Response to Submissions Report

Image 3.2.1 Onshore cable route options Z5-Z7 (Section ZB) (Image 5.23 of Chapter 5 of the 2024 EIAR)

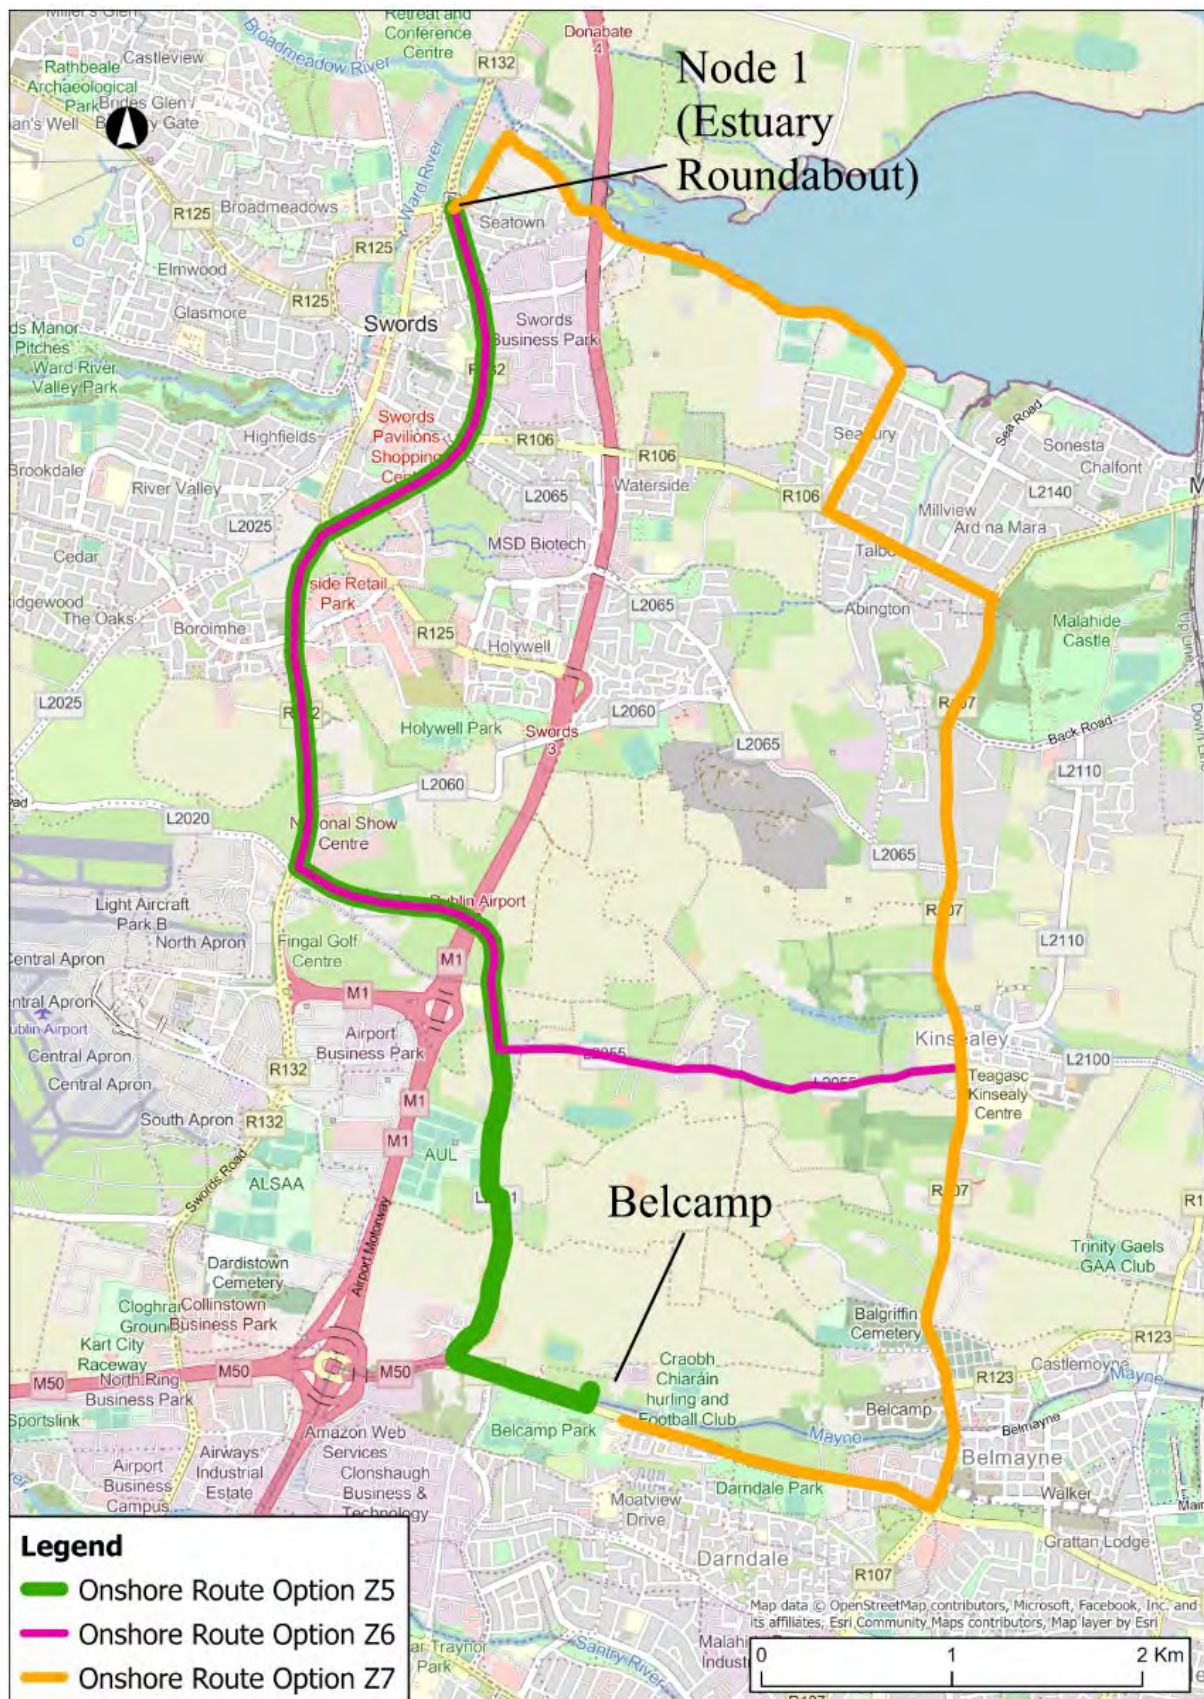
In particular, Submission No. 5 is concerned with the perceived weighting of environmental constraints in comparing alternative routes between Estuary Roundabout and Belcamp (classified as ‘Section ZB’ in Chapter 5 of the 2024 EIAR). The three route options (Z5 – Z7) for Section ZB are illustrated in Image 3.2.1.

For clarity, no weightings have been applied to assessment of alternatives. As detailed in Section 5.7.4.6 of the EIAR, the assessment was a comparative assessment.

Image 3.2.2 Onshore cable route options Z1-Z4 (Section ZA) (extracted from Image 5.22 of Chapter 5 of the 2024 EIAR)

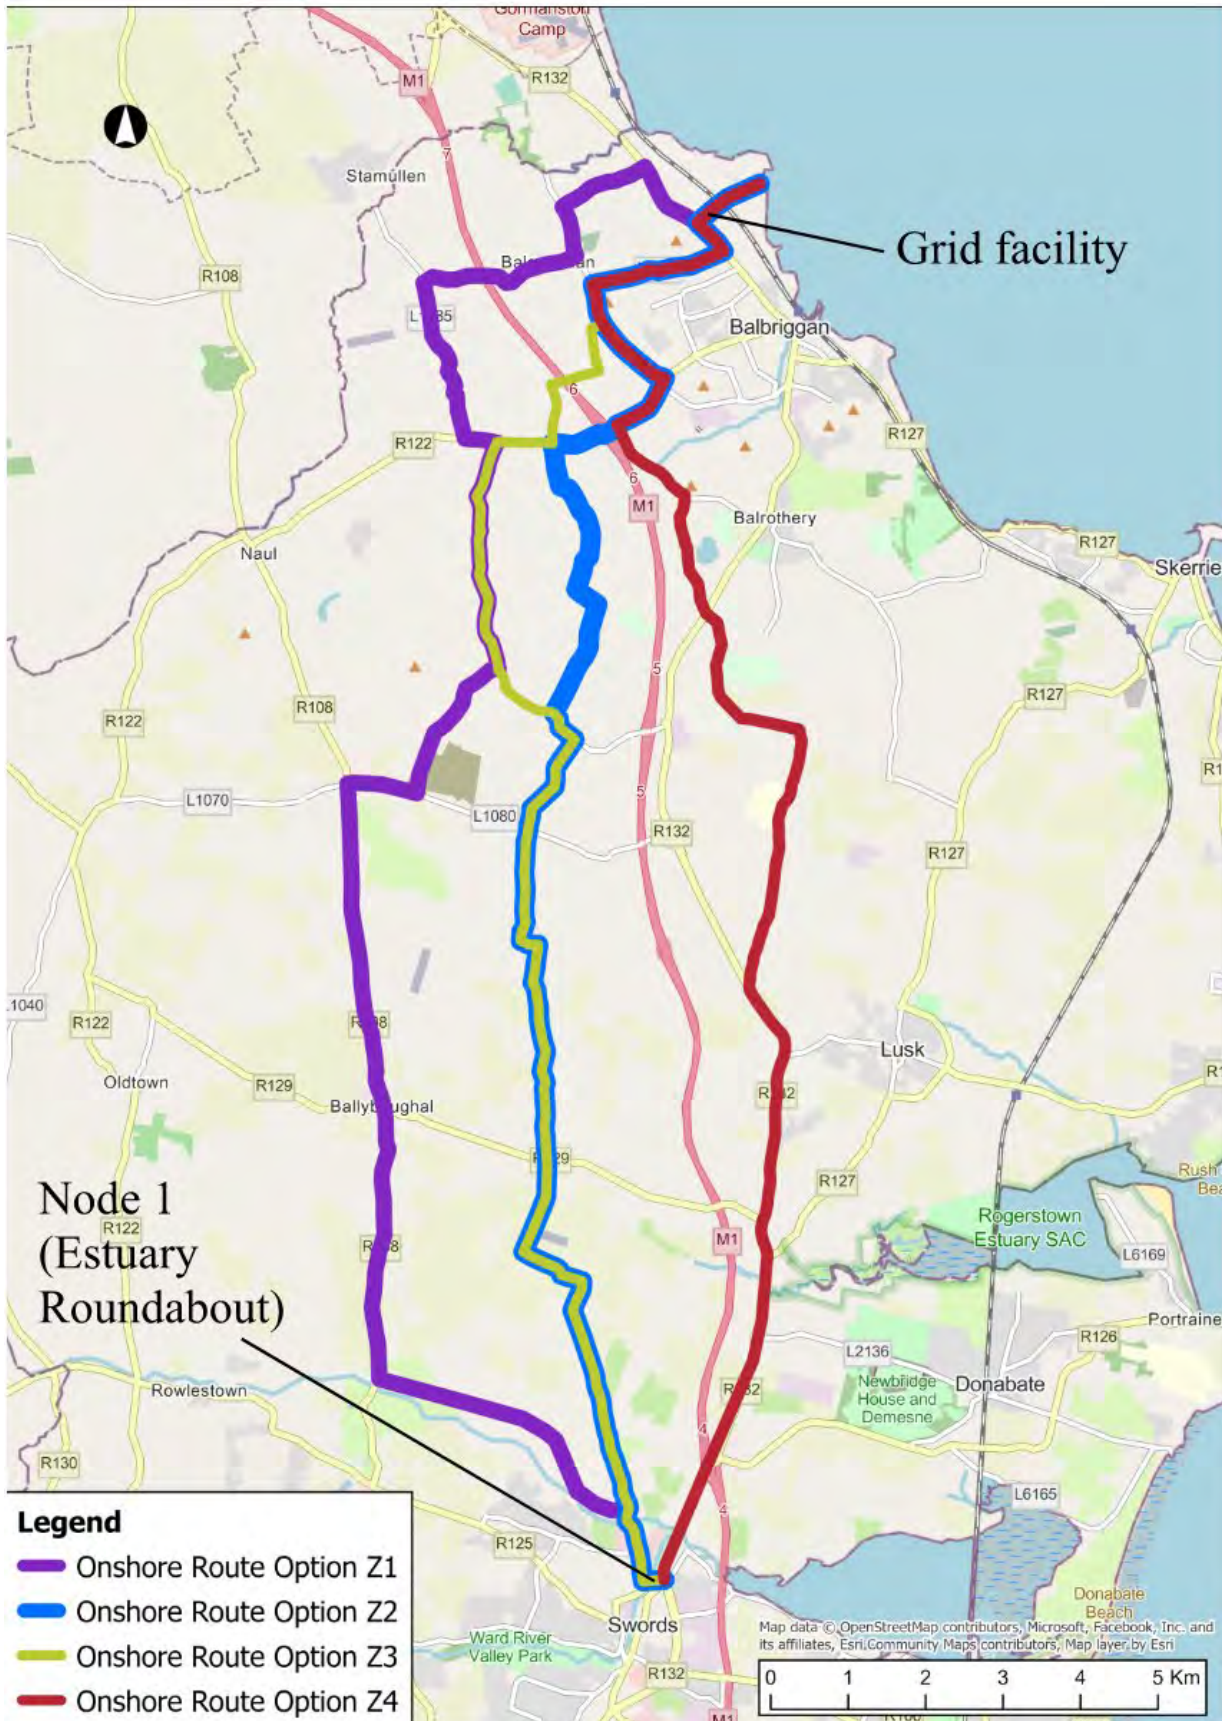
As described in Section 5.7.4.4 of Chapter 5 of the 2024 EIAR, a detailed assessment of reasonable alternatives for the cable route in Zone ZA (study area between the grid facility at Bremore and Estuary Roundabout – Node 1, which includes Balbriggan and its environs (see Image 3.2.2 below)) was undertaken. This identified an emerging preferred route, Z2, at the end of the feasibility study. As the design evolved and further technical information became available, it became clear that there were considerable challenges in terms of constructability and construction traffic management for this option, which involved the routing of the onshore cable along very narrow local and unmarked roads, to the west of the M1, particularly the section between the L5150 (Dermotstown Road) and Balheary Road, before rejoining the R125.

Consequently, as detailed in Section 5.7.4.8 of the EIAR, a route utilising more of the R132 was reconsidered, given that much of this road has a wide carriageway with verges and therefore is capable of accommodating larger volumes of traffic.

Image 4.2.1 Cultural Heritage sites near the landfall site (Extracted from Figure 25.1 of the 2024 EIAR)

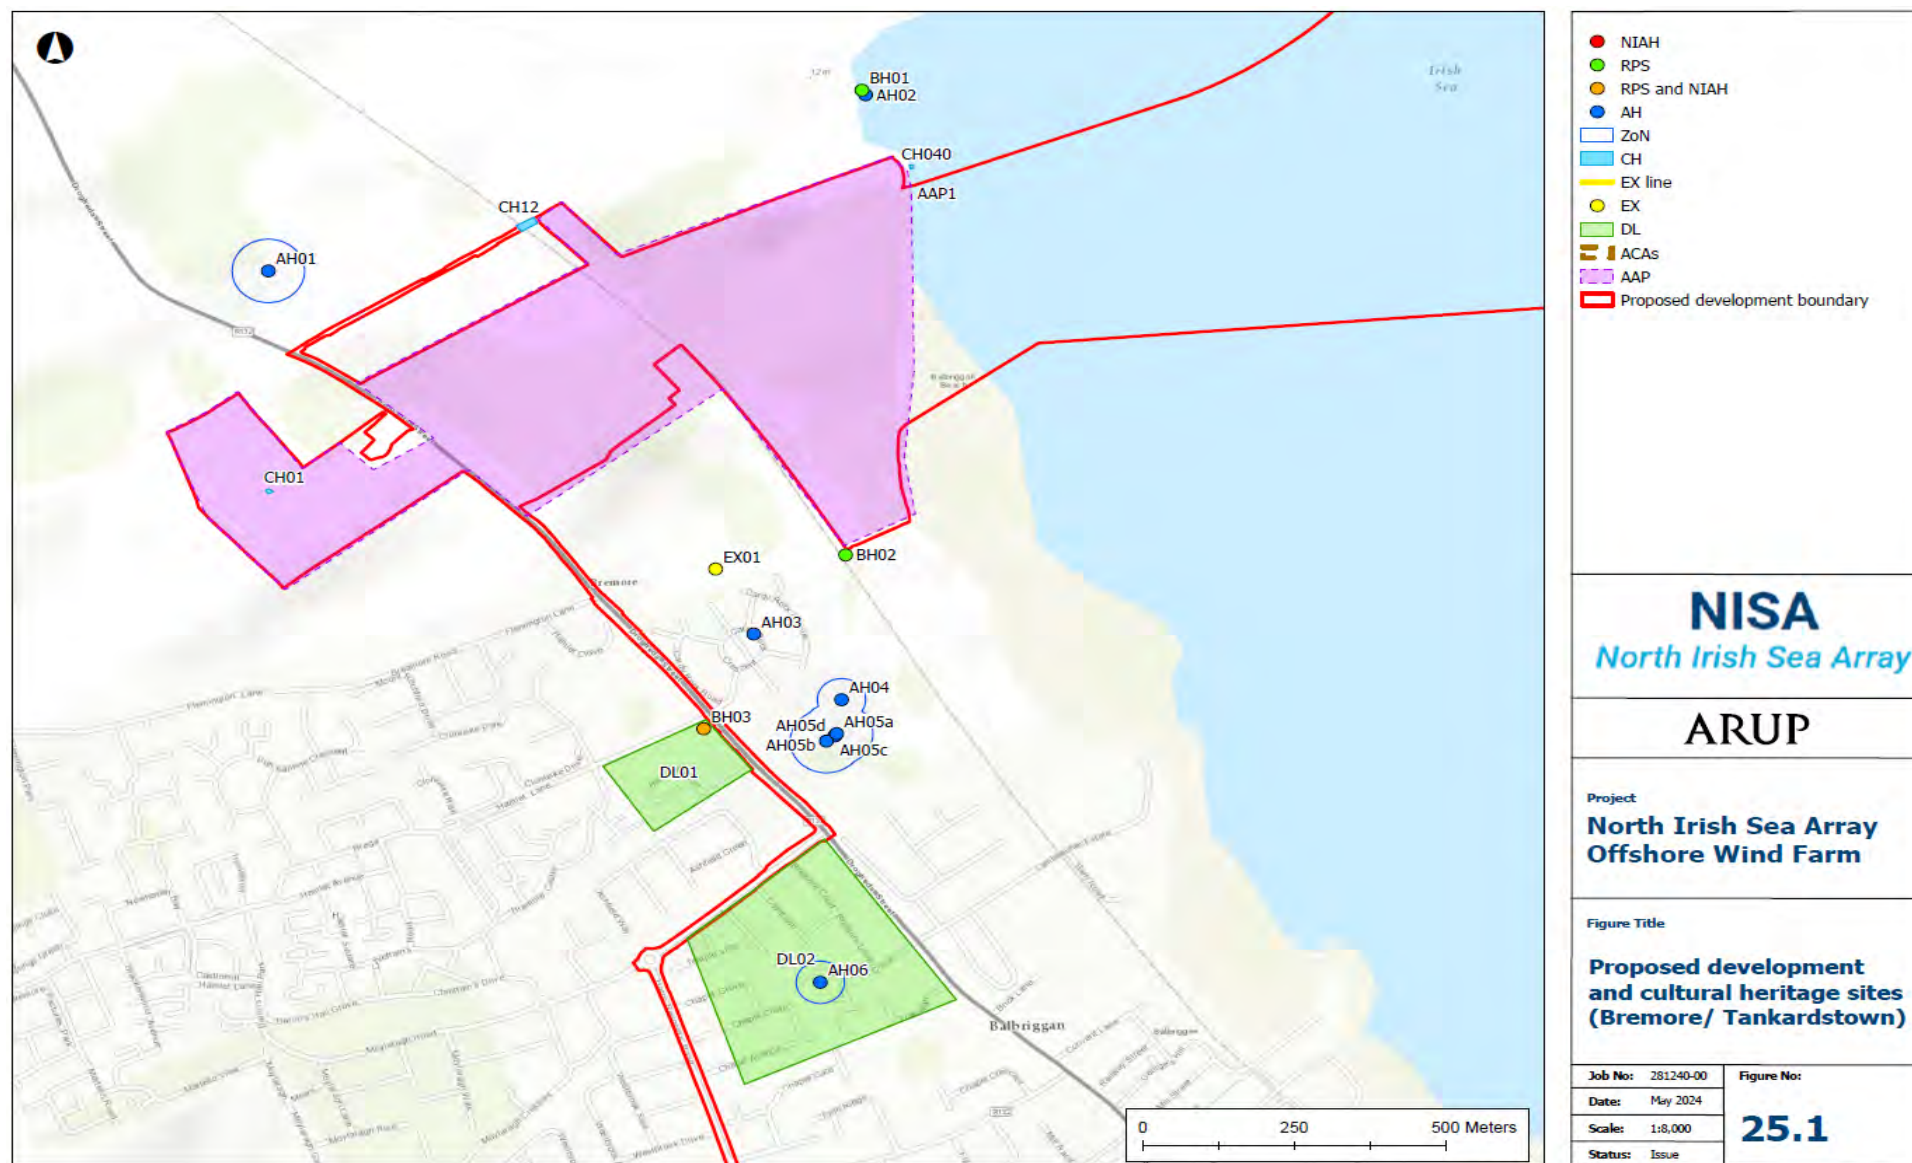
Chapter 25: Onshore Archaeology, Architectural and Cultural Heritage of the 2024 EIAR considered impacts to all protected structures (which are denoted ‘BH sites’ in the chapter) in the study area. The study area was defined in Section 25.2.2 as *“the onshore development area (all infrastructure located landward of the HWM) and an area extending c. 250m from the edge of the onshore development area for archaeological, architectural, and cultural heritage sites and c. 50m (along the cable route of the onshore development area) for architectural sites.”*

Newhaven Quay (BH01) was included in the baseline assessment and assigned a sensitivity rating of High. However, it is situated c. 120m north of the landfall site. As noted in Section 25.5.2.1, *“construction within the landfall site will not result in any direct construction impacts on recorded archaeological or architectural sites (AH/BH) as any such sites are located outside of the onshore development area.”* Therefore, there will be no likely significant effects arising from the proposed development on Newhaven Quay. Refer to Image 4.2.1 below (extracted from Figure 25.1 of the 2024 EIAR) for the location of Newhaven Quay (BH01) and the proposed development boundary.

Figure 4.7.1 Minimum Distances Between Wicklow/Dublin Main Commercial Routes and Refined Project Option 1

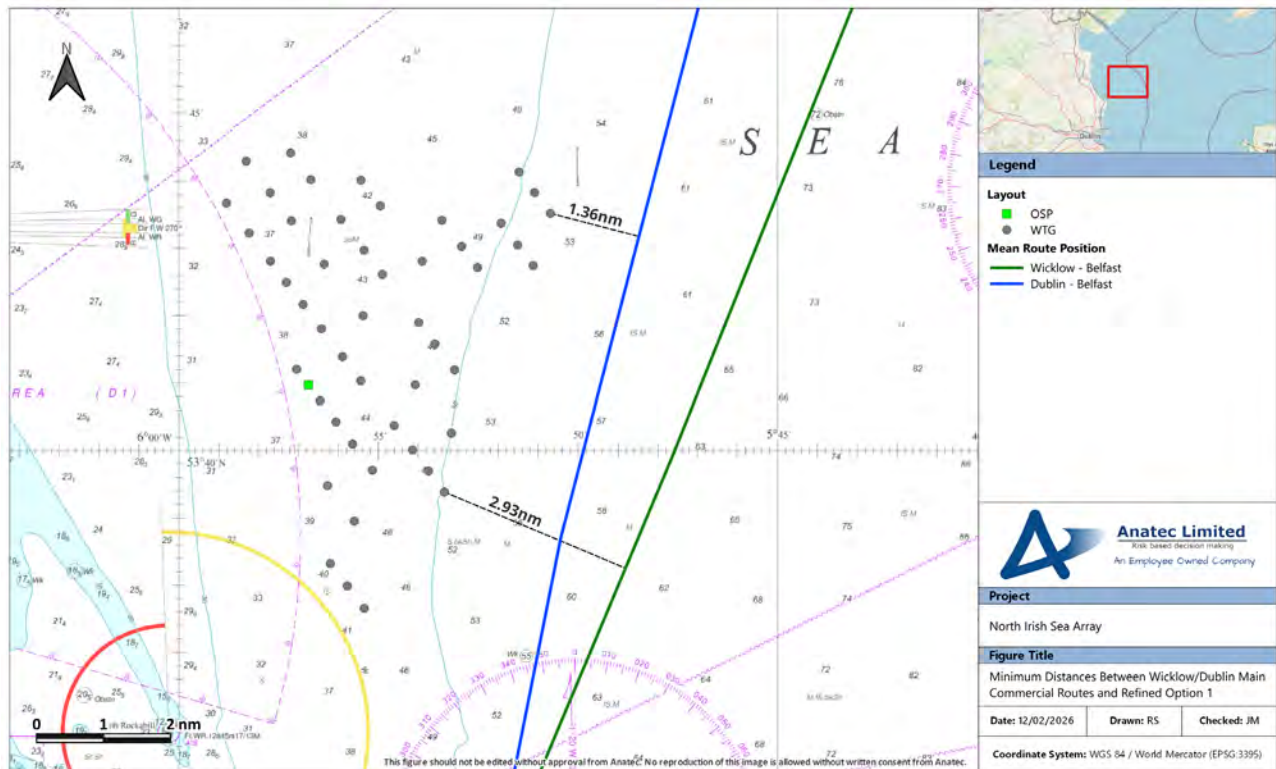
Response Point 1 - Micro siting of WTG

Following consultation feedback received, including from DoT (MSO) in addition to the Irish Coast Guard (IRCG) and Commissioners of Irish Lights (Irish Lights) the layouts have been revised accordingly. The extent of the WTGs within the array area has reduced at the south-eastern extent resulting in the main commercial routes passing north-east/ south-west out of Dublin (and Wicklow) no longer requiring a deviation. Subsequently, there is increased navigable sea room for vessels operating on these routes as illustrated in Figure 4.7.1 for the refined Project Option 1 and the disruption to commercial vessel routing is considered As Low as Reasonably Practicable (ALARP). This refinement has been welcomed by DoT (MSO) when presented during consultation, with DoT (MSO) confirming that the refined layouts increase navigable sea room for all users compared to those assessed in the 2024 Environmental Impact Assessment Report (2024 EIAR).
